Project	<b>IEEE 802.16 Broadband Wireless Access Working Group</b> < <a href="http://ieee802.org/16">http://ieee802.org/16</a> >	
Title	<b>Frame structure for support of multihop relaying</b>	
Date Submitted	<b>2007-01-08</b>	
Source(s)	<p>Mike Hart Fujitsu Laboratories of Europe Ltd. Hayes Park Central Hayes, Middx, UB4 8FE, UK</p> <p>Dorin Viorel Fujitsu Microelectronics Canada Inc.</p>	<p>Voice: +44 20 8606 4523 Fax: +44 20 8606 4539 <a href="mailto:mike.hart@uk.fujitsu.com">mike.hart@uk.fujitsu.com</a></p>
Re:	Call for technical proposals IEEE 802.16j-06/034.	
Abstract	<p>This contribution provides a text proposal that provides simple clarifications to the existing text in the baseline document that defines the two-hop in-band frame structure for the TDD mode of the OFDMA PHY to enable support for more than two-hop relaying. As a result of the proposed clarifications it will be possible to support extension to multihop via two different configurations. The first is via a superframe or multi-phase approach which involves defining one relay-zone per subframe and changing the structure of the frame at the RS and MR-BS based on the frame number. The second is via partitioning the s

**Figure <xxx+1>—Example 2 of minimal configuration for an in-band non-transparent relay frame structure (super-frame approach) for more than two-hop communication for (a) odd frame number; (b) even frame number.**

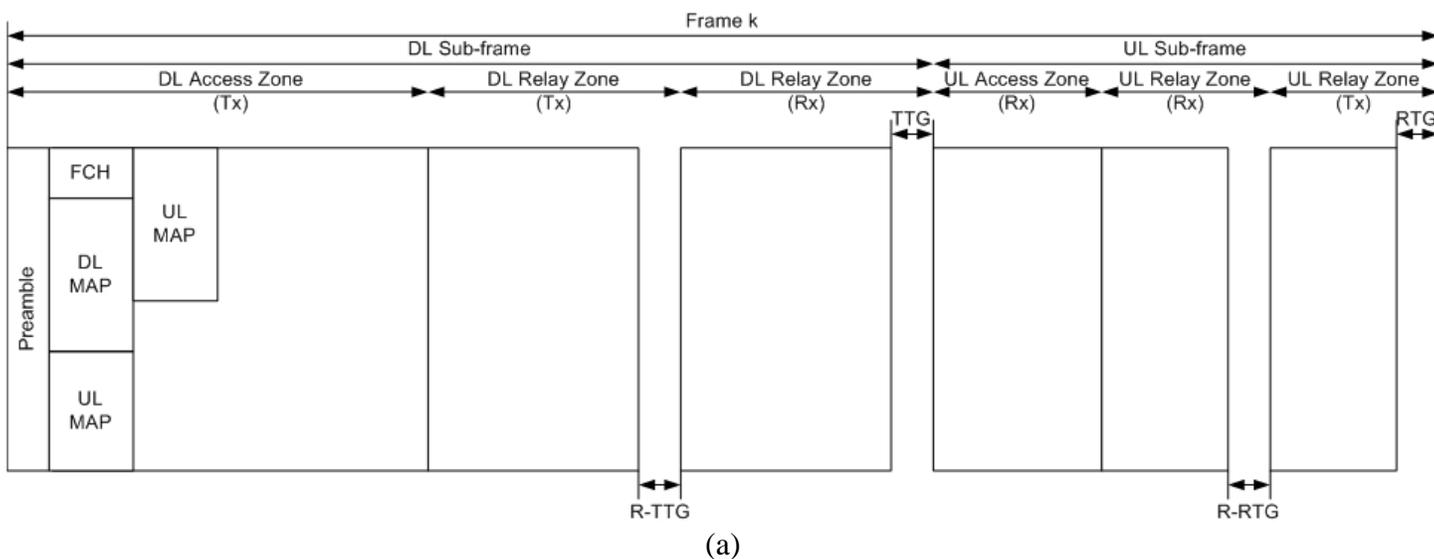
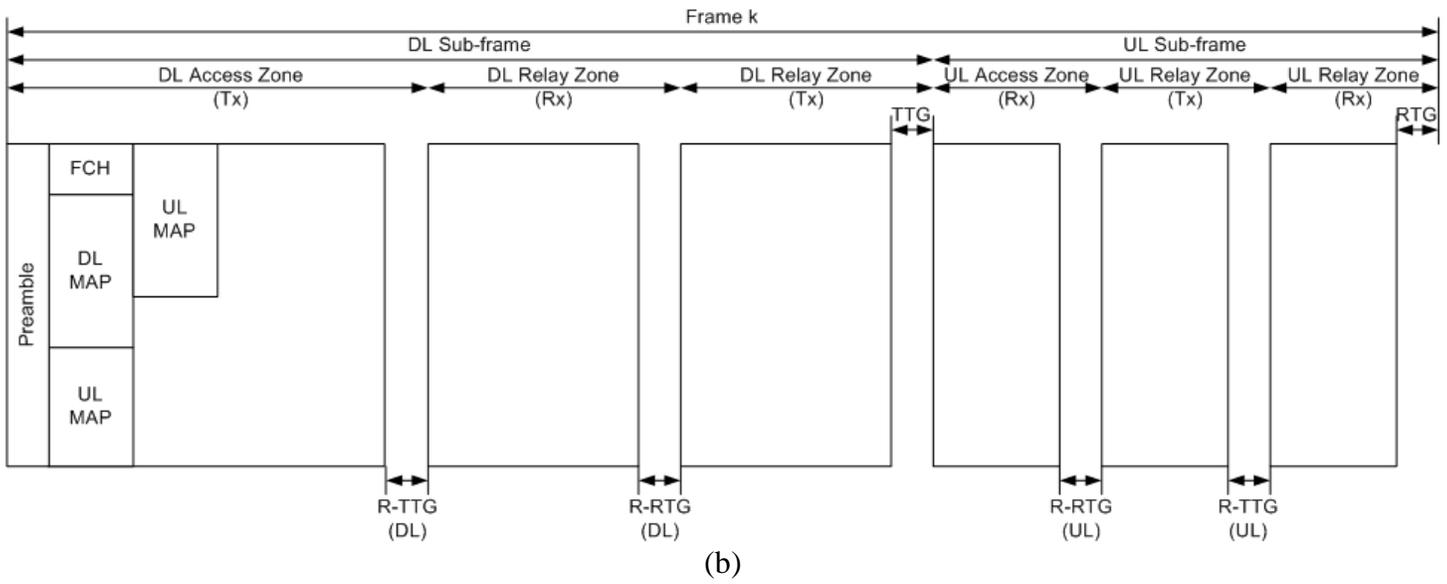
For the TDD mode, an example of an RS frame structure for two-hop relaying is shown in Figure <xxx>. Two methods for supporting more than two hop relaying are defined. An RS shall be capable of being configured to support either one of the methods, but shall not be required to support both simultaneously. The first approach uses different two-hop RS frame structures at an odd and even hop numbered RS, as illustrated in Figure <xxx> (a) and (b) for an odd hop number and even hop number RS, respectively. The second approach uses different two-hop RS frames structures at an RS for odd and even frame numbers, as illustrated in Figure <xxx+1> (a) and (b) for an odd frame number and even frame number, respectively.
